TRANS/WP.29/GRSP/2001/11
28 February 2001

World Forum for Harmonization of Vehicle Regulations (WP29.)

**PROPOSAL FOR DRAFT AMENDMENTS (SUPPLEMENT 2 TO THE 01 SERIES)
TO REGULATION No. 21
(Interior fittings)**

Transmitted by the Experts from Spain and Germany

FIGURE 1

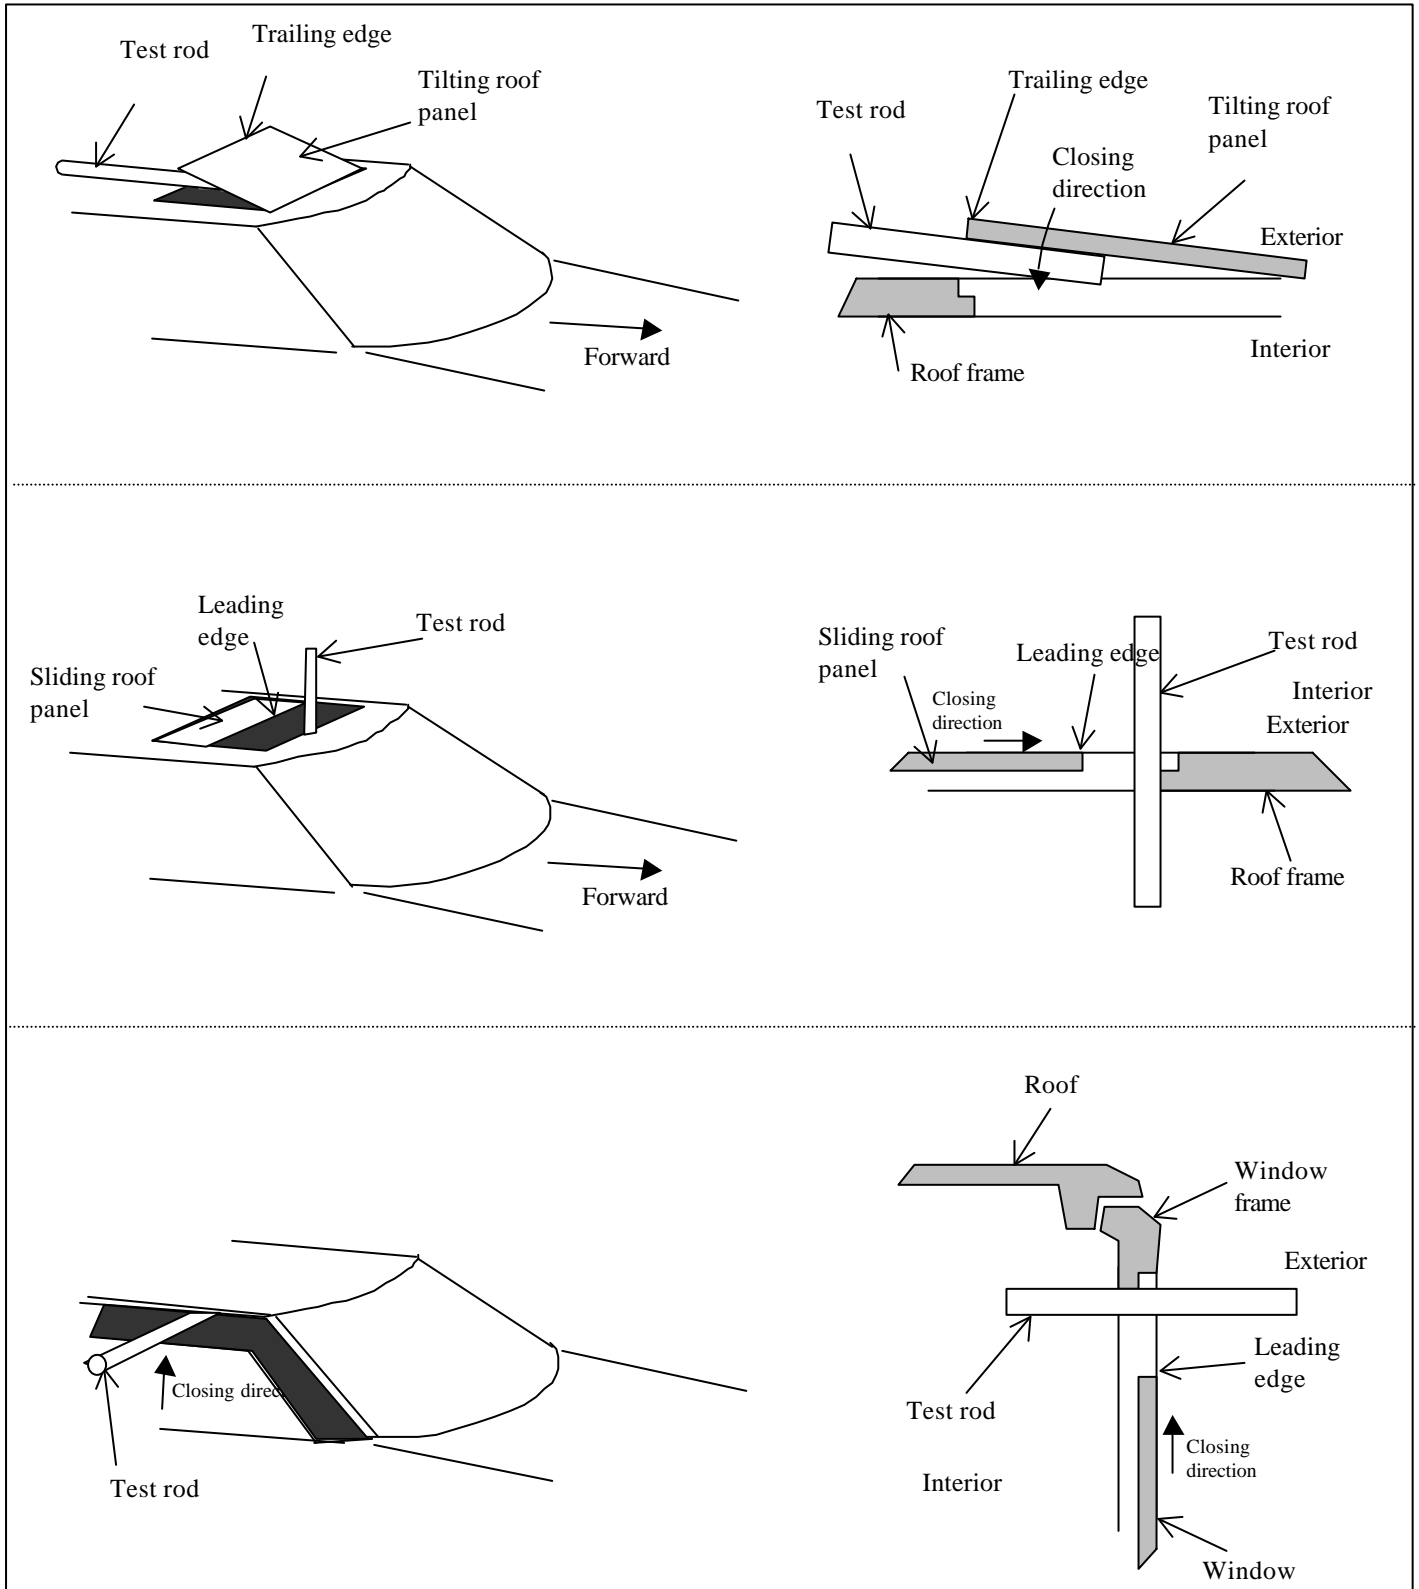
- 5.8.3.1.1. This device shall reverse the window/roof panel/partition before it exerts a pinch force of more than 100 N within the opening of 200 mm to 4 mm above the top edge of a power-operated window/partition or in front of the leading edge of a sliding roof panel and at the trailing edge of a tilting roof panel.

TYPICAL POSITION OF CYLINDRICAL TEST ROD IN THE OPENING ROOF AND WINDOW OPENINGS

FIGURE 2

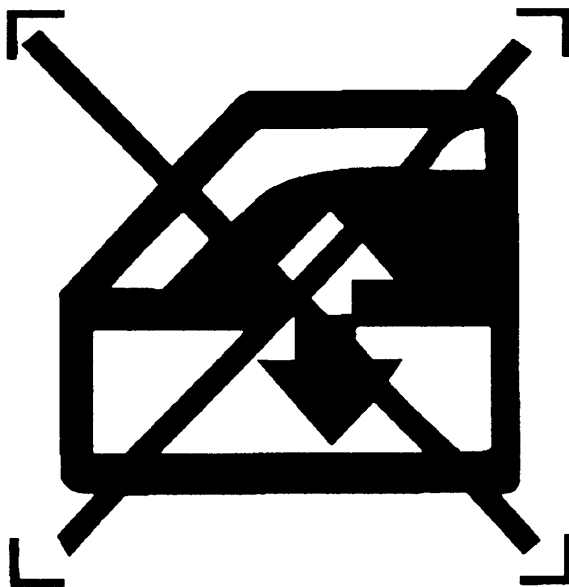
5.8.4.2. All rear-window, roof-panel and partition switches intended for use by occupants in the rear of the vehicle shall be capable of being switched off by a driver-controlled switch which is located forward of a vertical transverse plane passing through the R points of the front seats. The driver controlled switch is not required if a rear window, roof panel or partition is equipped with an auto-reversing device. If, however, the driver-controlled switch is present, it shall not be able to override the auto-reversing device **or prevent lowering of the partition system.**
The driver-controlled switch shall be located so as to minimize any accidental manipulating. It shall be identified by the symbol shown in **Figure 2 of annex 9 to this Regulation or an equivalent symbol, for example according to ISO 2575:1998 reproduced in figure 3 of annex 9 to this Regulation.**

EXAMPLES OF SYMBOLS FOR DRIVER CONTROLLED SWITCH

Paragraph 2.5.

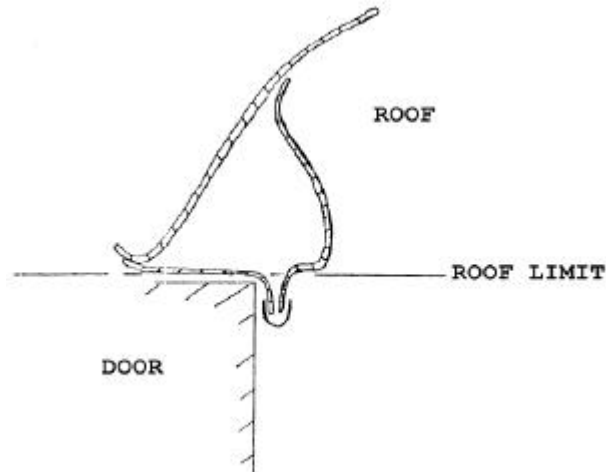
At the vehicle sides the roof shall commence at the upper edge of the door aperture. In the normal case, the lateral roof limits will be represented by the contours formed by the bottom edge (lateral view) of the remaining body when the door has been opened. In the case of windows, the lateral limitation of the roof will be the continuous transparent line (penetration point of the lateral windowpanes). At the posts, the lateral roof limitation will pass through the connecting line between the transparent lines. The definition of paragraph 2.5. is also valid for any opening for the roof, in the closed position, of a vehicle as defined in paragraphs 2.7. or 2.8. For measuring purposes, downward facing flanges shall be ignored. These will be considered as forming part of the vehicle sidewall.

Paragraph 5.1.1.

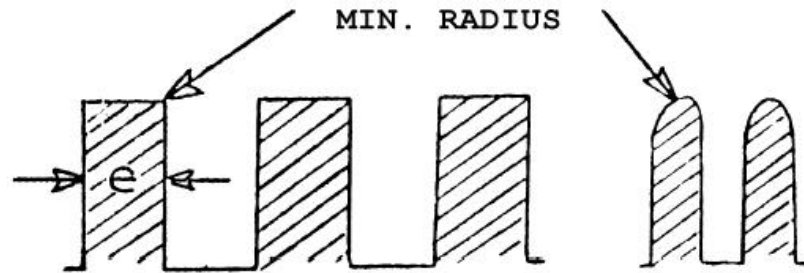
Grills are considered to comply with the regulations if they meet the minimum requirements of the following table:

Gap between elements [mm]	Flat elements		Rounded elements min. radius [mm]
	e/min. [mm]	min. radius [mm]	
0 - 10	1.5	0.25	0.5
10 - 15	2.0	0.33	0.75
15 - 20	3.0	0.50	1.25

Paragraph 5.1.5.

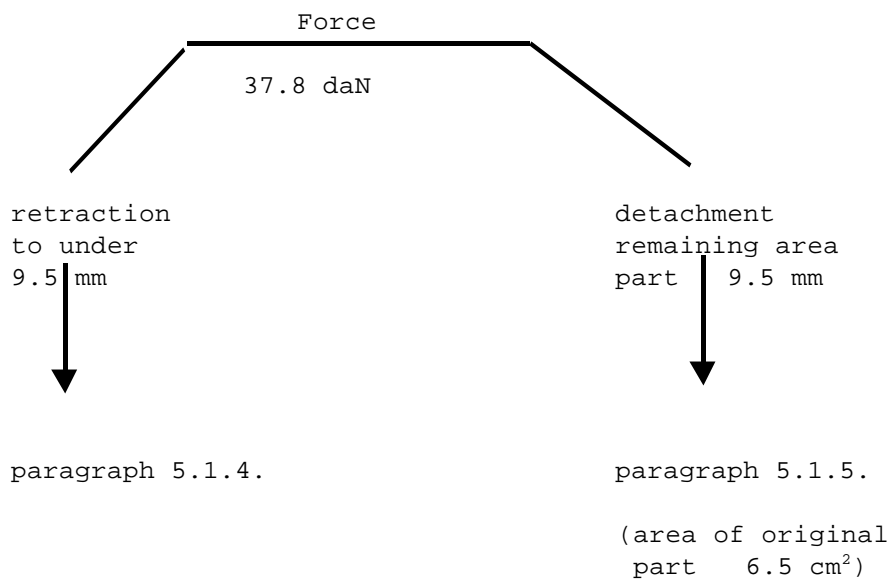
Paragraphs 5.1.4. and 5.1.5. complement each other; the first sentence of paragraph 5.1.5. (i.e. a force of 37.8 daN for retraction or detachment) is applied and then paragraph 5.1.4. in case of retraction up to a protrusion between 3.2 and 9.5 mm or, in the case of detachment, the two last sentences of paragraph 5.1.5. (the cross-section area is measured before the force is applied). However, if, under practical circumstances paragraph 5.1.4. must be applied (retraction to under 9.5 mm and over 3.2 mm) it could be more convenient, at the manufacturer' s discretion, to verify the specifications of paragraph 5.1.4. before applying the force of 37.8 daN specified in paragraph 5.1.5.
